Metropolitan Development Commission Plat Committee (April 8, 2026) Meeting Agenda

PLAT COMMITTEE **April 7, 2026**

2026PLT011: Proposed Plat

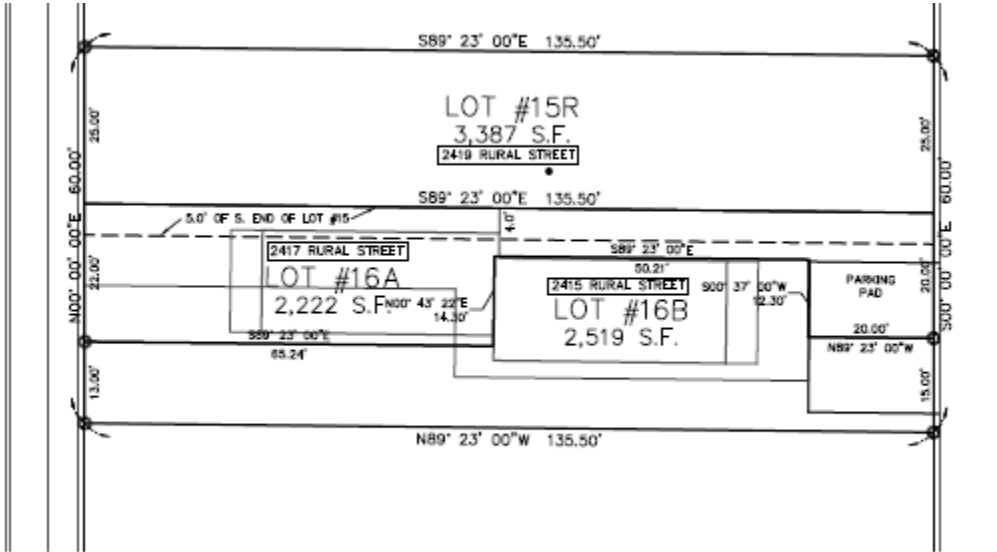
Existing Zoning	D-5	
Existing Land Use	Single-Family attached dwelling	
Comprehensive Plan	Traditional Neighborhood	
Surrounding Context	Zoning	Land Use
North:	D-5	Single-Family Attached Dwelling
South:	D-5	Single-Family Attached Dwelling
East:	D-5	Single-Family Residential
West:	D-5	Single-Family Residential
Thoroughfare Plan		
Rural Street	Local Street	60-foot existing and 48 feet proposed
Petition Submittal Date	October 2025
